Landpro Reference: 19474

Council Reference: RM20.360

**Request for Further Information under Section 92(1) of the Resource Management Act
1991 – Cromwell Certified Concrete**

Figure 2: Average monthly climate data for Cromwell (evapotranspiration significantly exceeding rainfall during the summer months) Data source: NIWA Cliflo database, Cromwell EWS station, May 2006-December 2018.

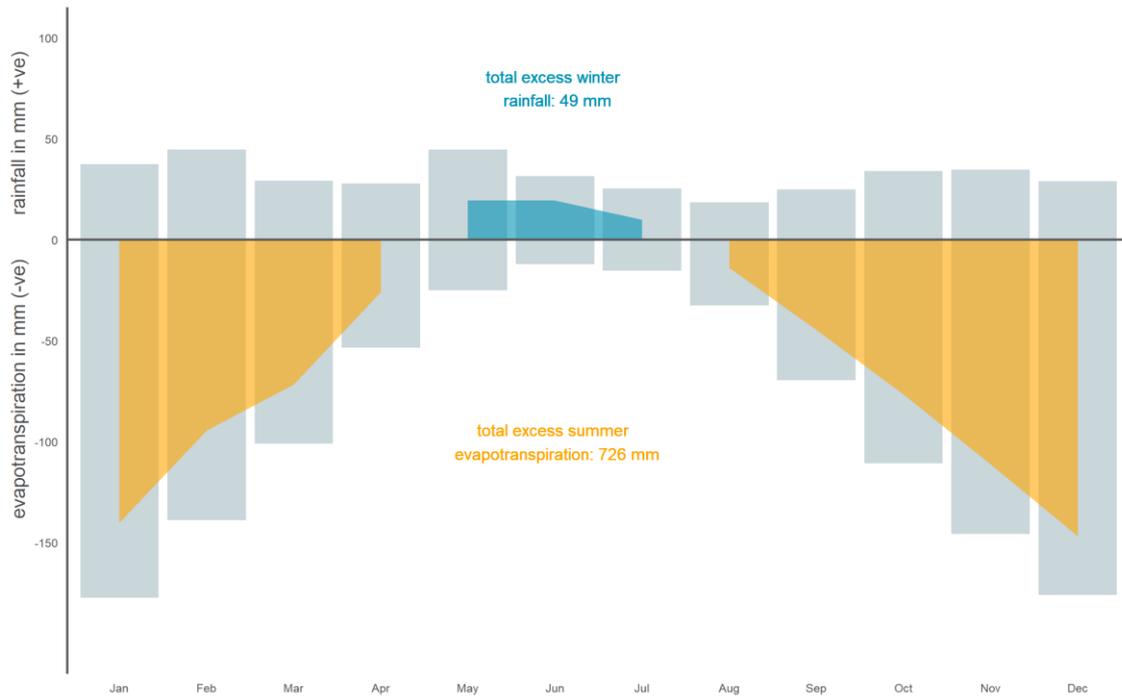
Please provide more information on the operation of the soakage pits, including evaporation losses."

You have asked about evaporation losses. The graph below illustrates the monthly balance at Cromwell between rainfall and evapotranspiration.

Grow Otago² estimates the soil moisture deficit to be an annual mean of approximately 420 mm and the total area of the soakage pits is approximately 4,140 m². Therefore on average the ponds will lose approximately 1,739 m³/year as evaporation.

Appendix A Copy of full pumping test for bore G41/0456

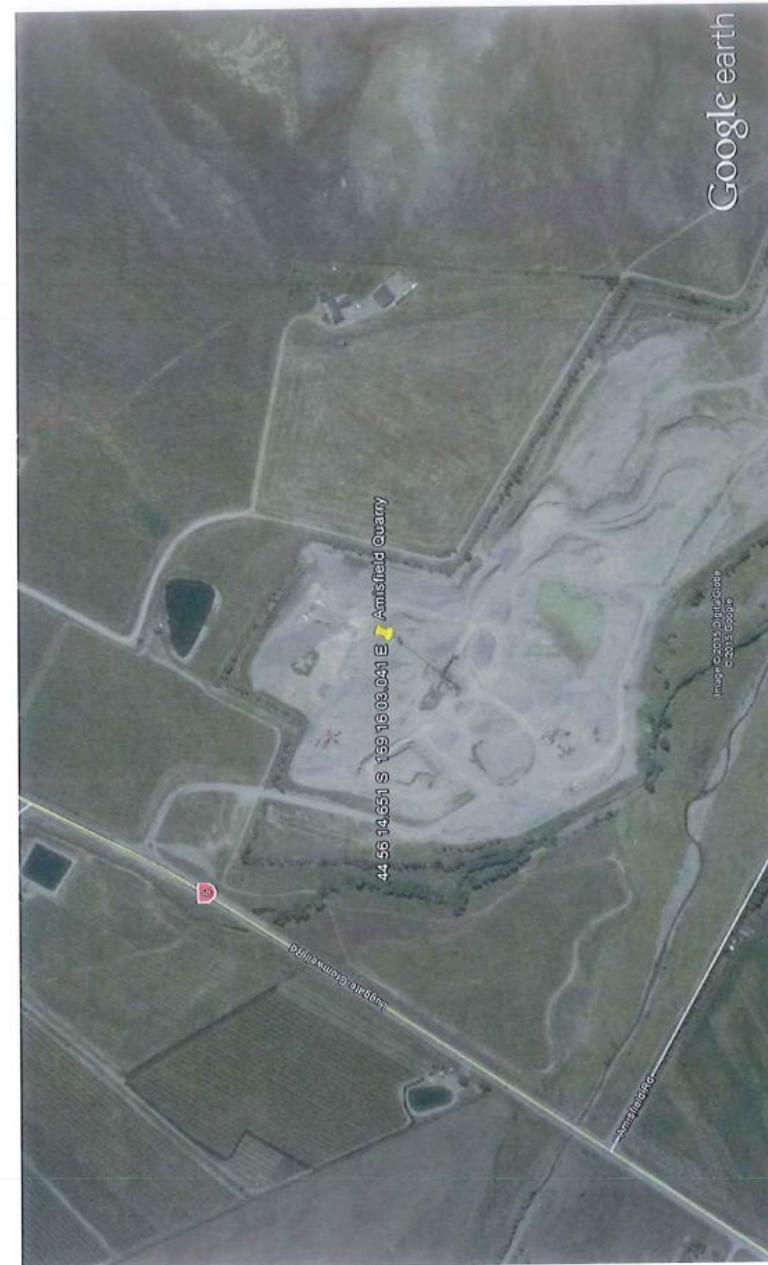
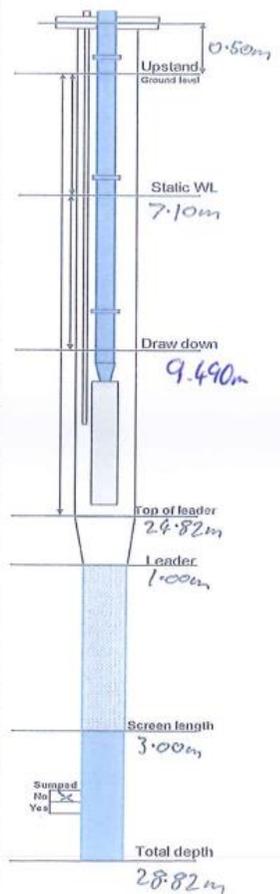
The e3 Scientific report (thanks for providing that) refers to a pump test of G41/0456 while the earlier ORC report referred to a pumping test on G41/0455. There may be a bore numbering error in the earlier report. We have attached a copy of the full original pumping test as Appendix A.
